Value Engineering For Transportation Improvements

SR 429 (Wekiva Parkway)/SR 417 and I-4 Interchange

Value Engineering Study Final Report

Project Description: Wekiva Parkway/SR 417 and I-4 Interchange

RECOMMENDATION No. 32: Increase the ramp profile to eliminate replacing the CR 46A Bridge

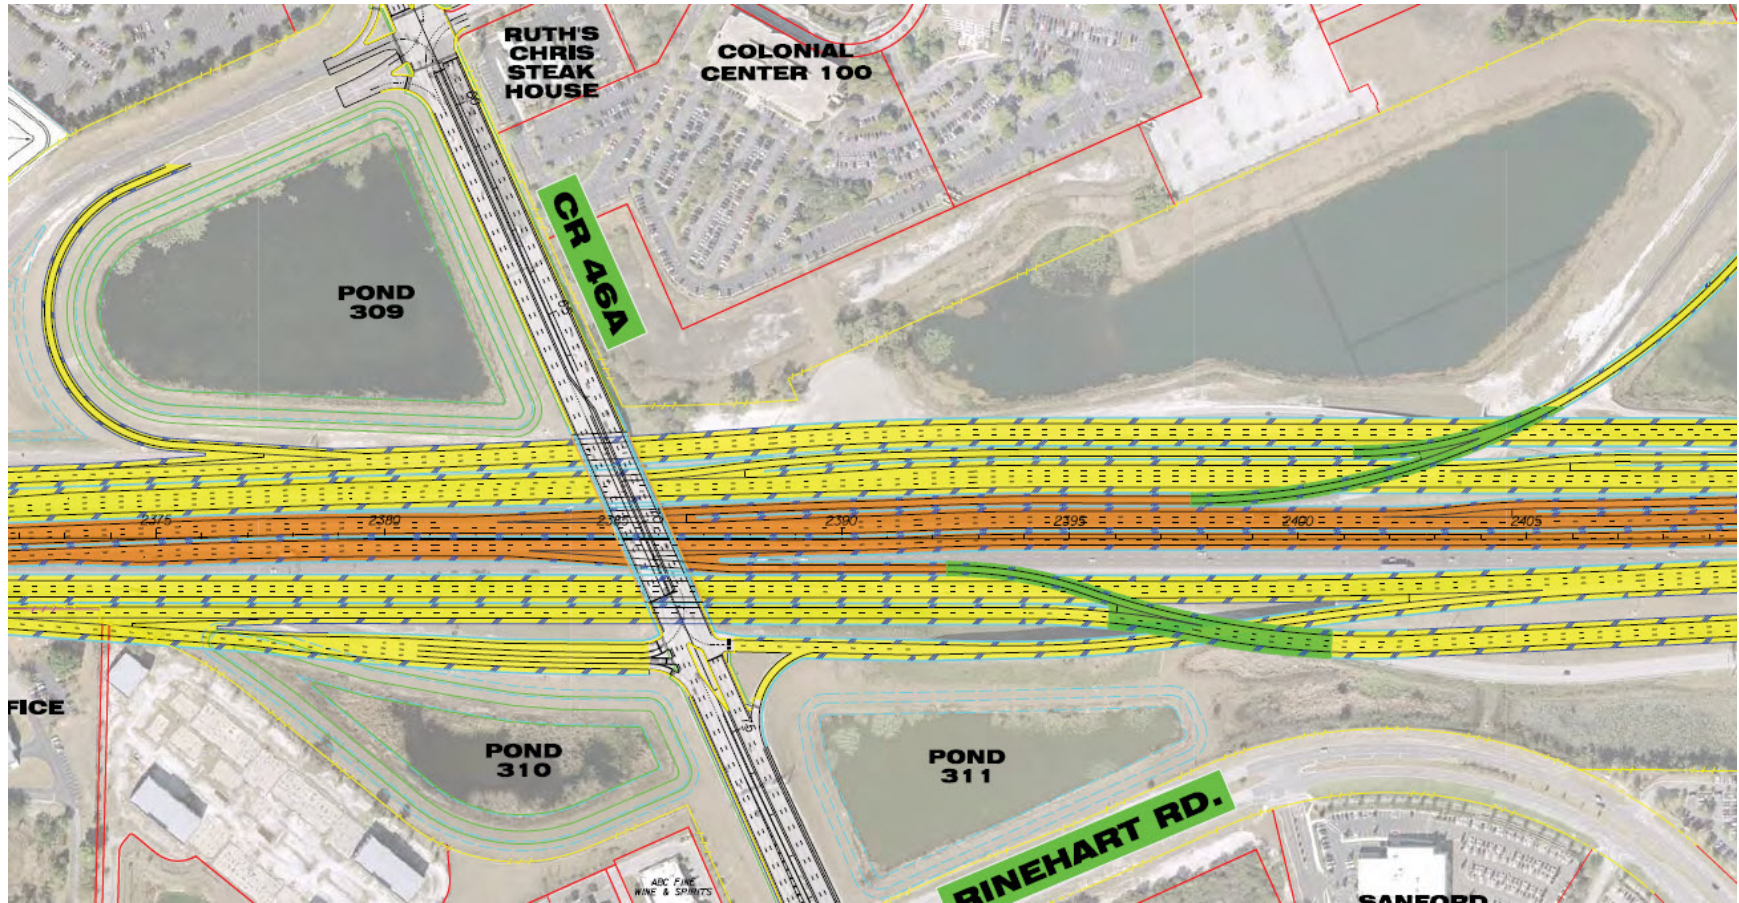
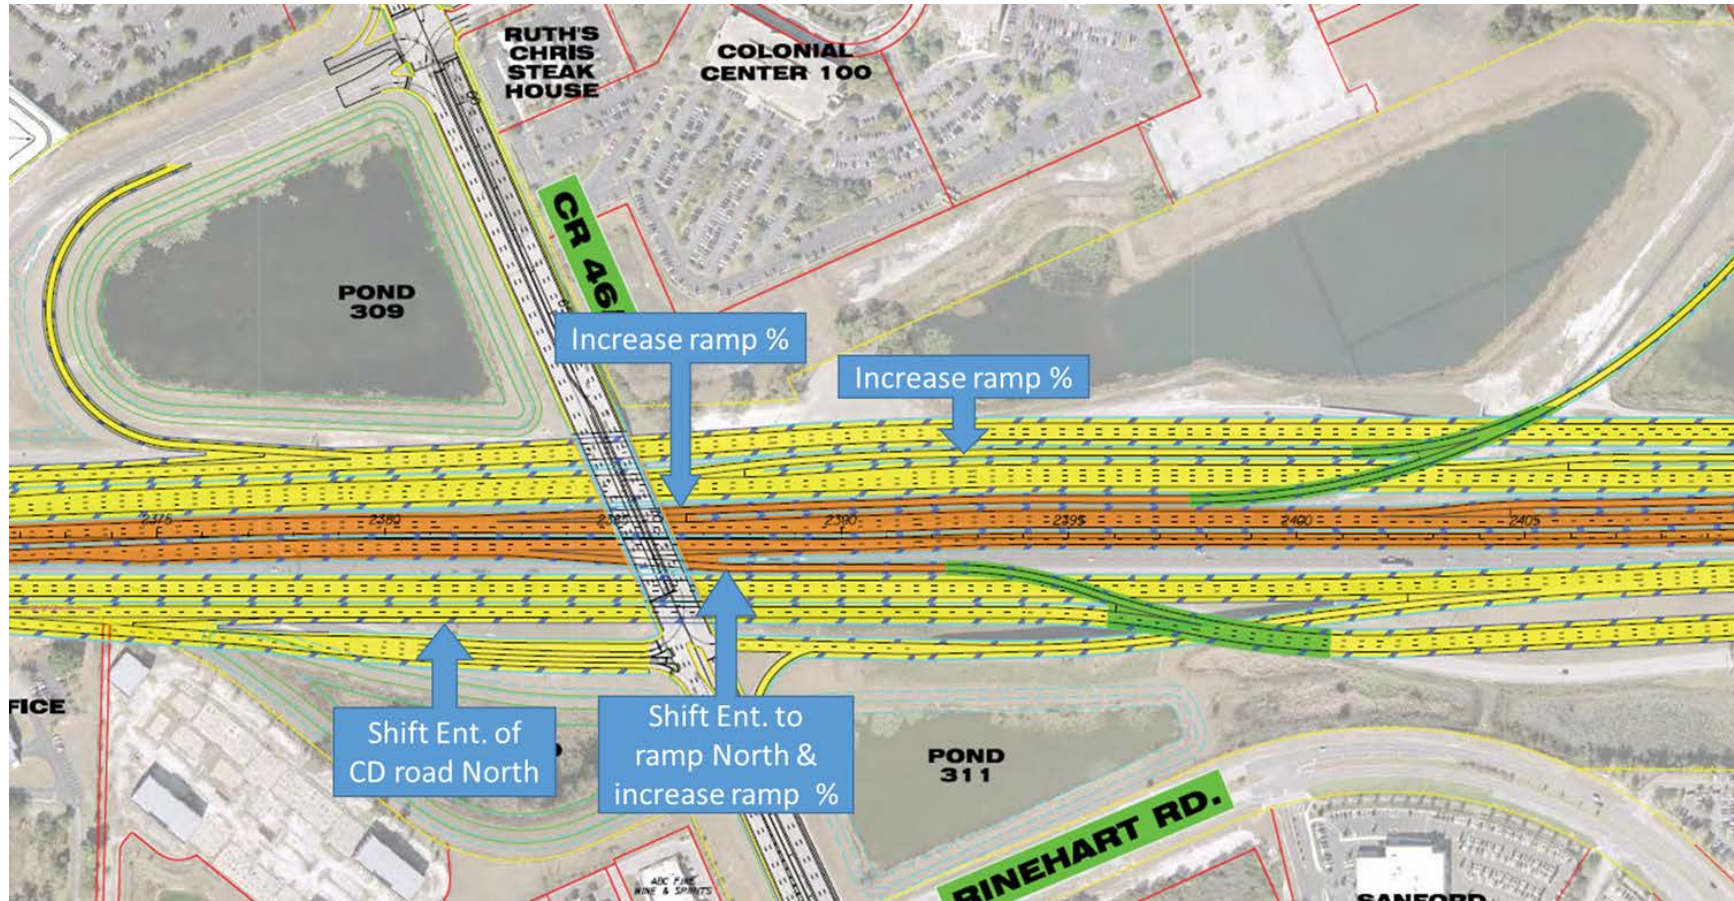
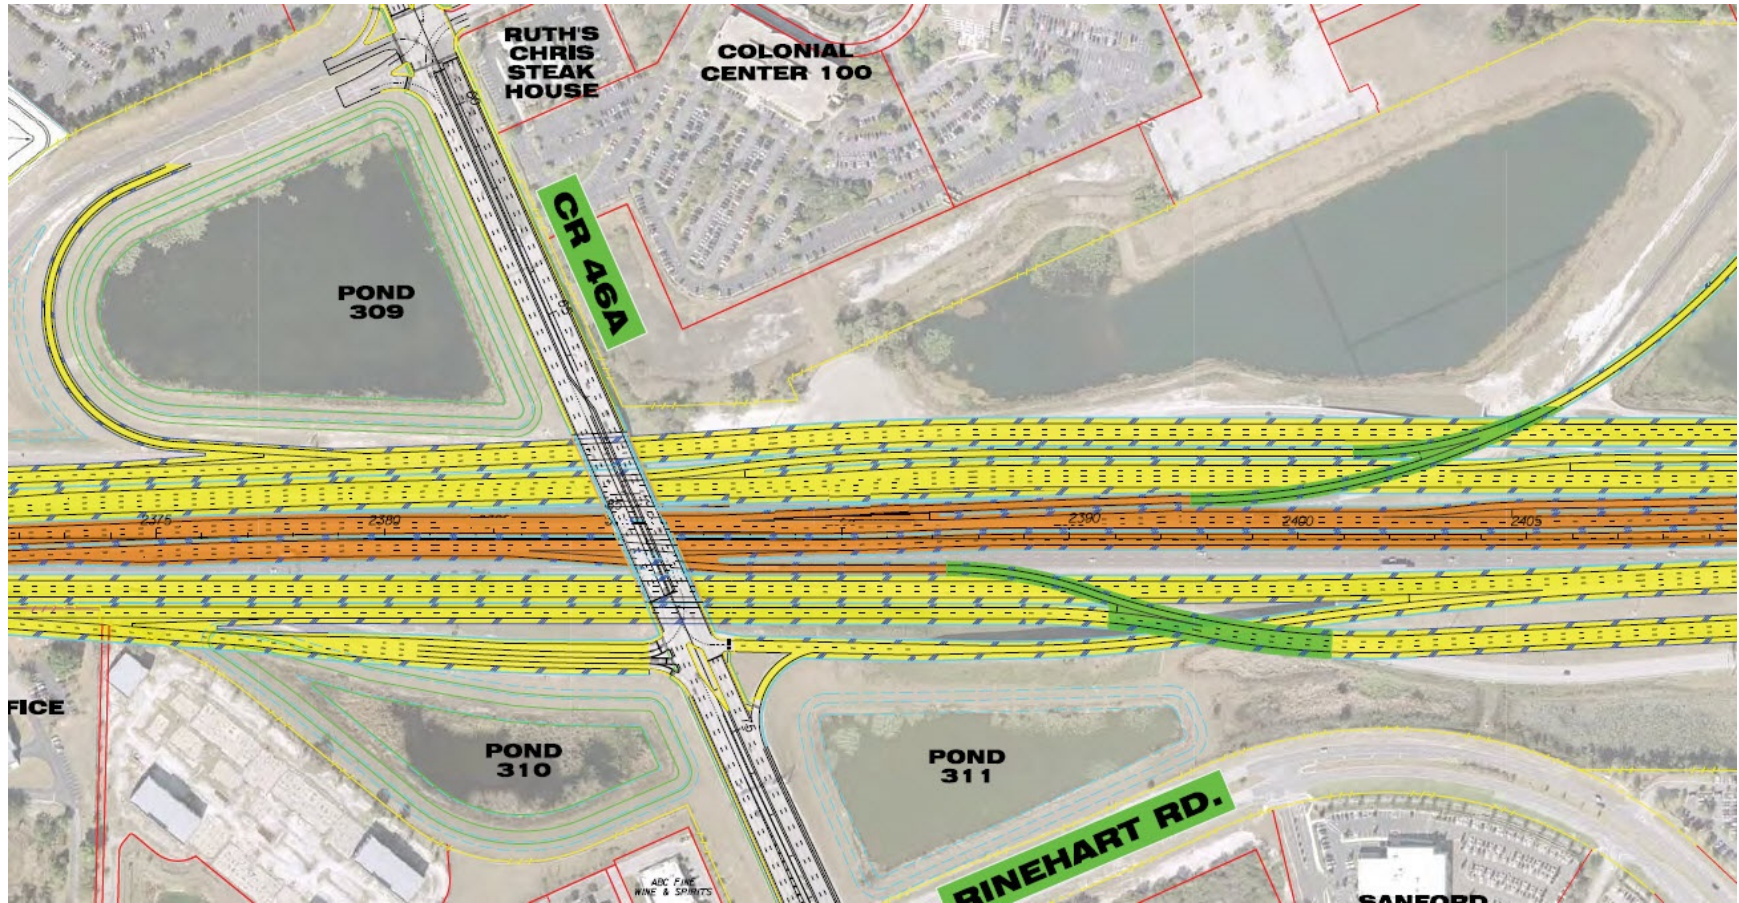
The PD&E Documents show long ramp profiles near the CR 46A bridge including the ramp from I-4 eastbound to SR 417/SR 429 and the ramps from SR 429 to I-4 westbound.

RECOMMENDATION No. 33: Cul-de-sacs for Wilson Road to allow for Wekiva Parkway to be at grade

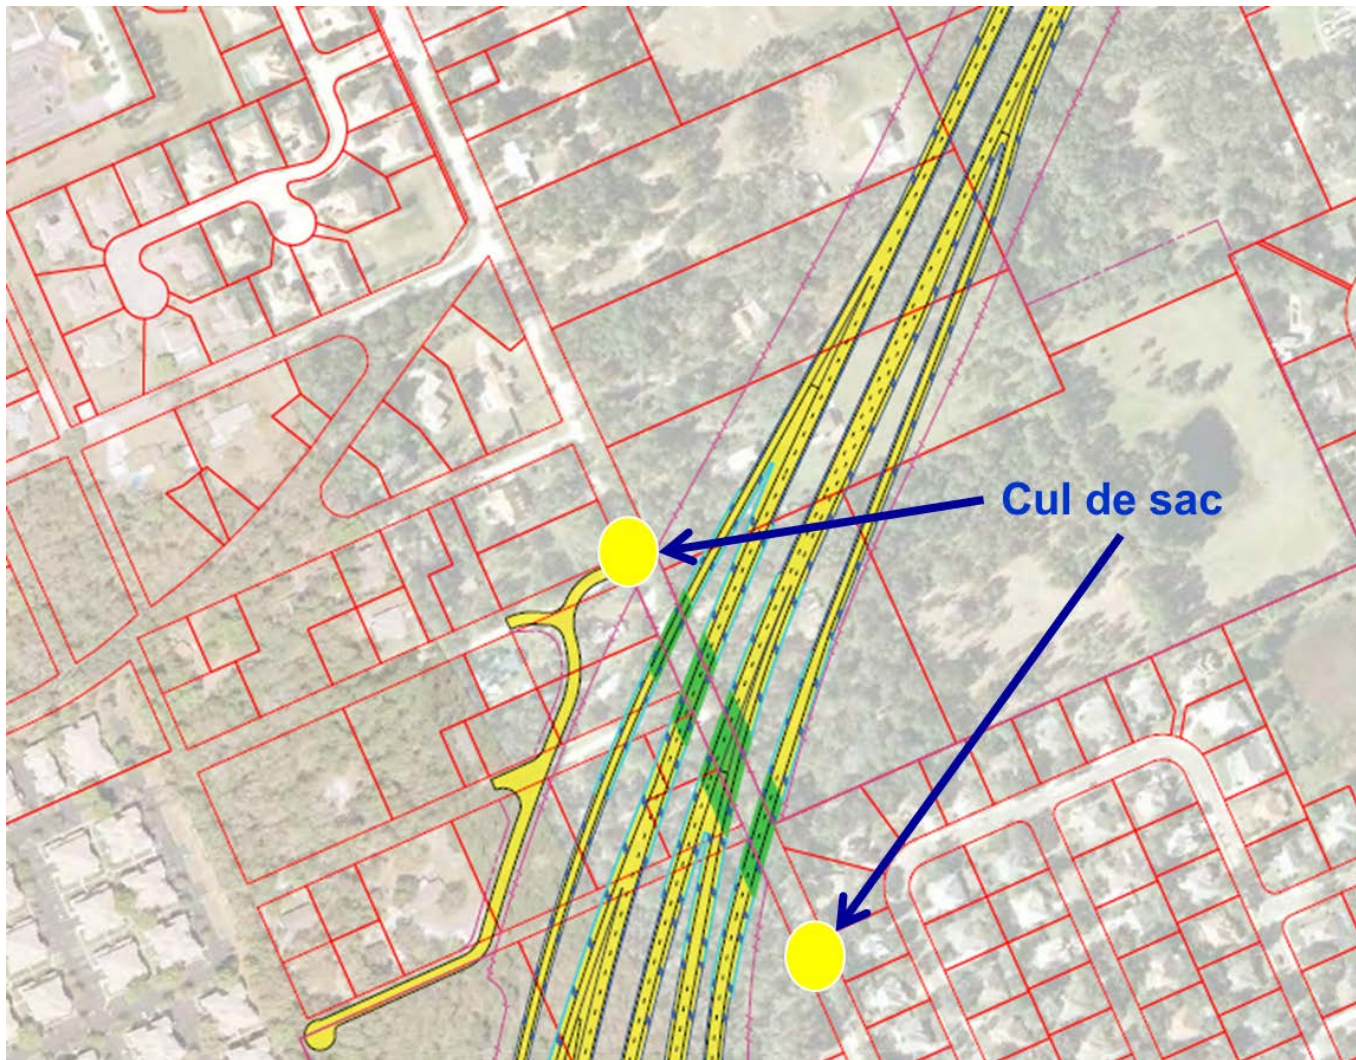
The PD&E Documents show two eastbound and two westbound bridges on SR 429 to span Wilson Road. Each bridge is approximately 160 feet in length.

RECOMMENDATION No. 34: Don't construct the International Parkway Interchange with SR 429

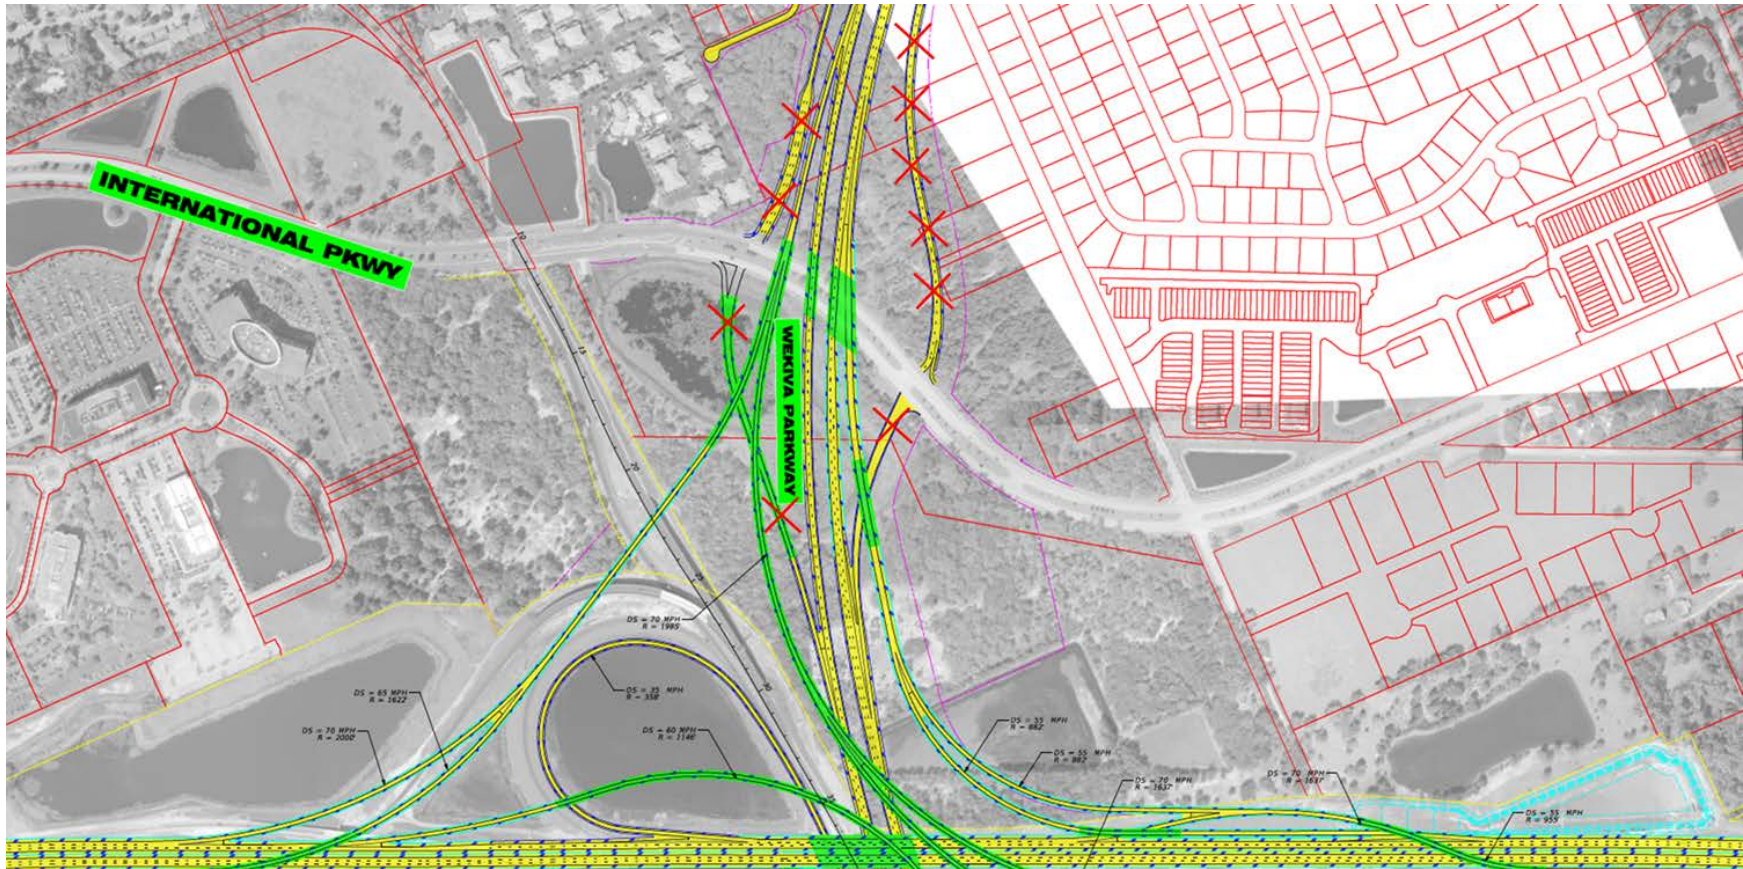
The PD&E Documents show a full Interchange at International Parkway and SR 429.
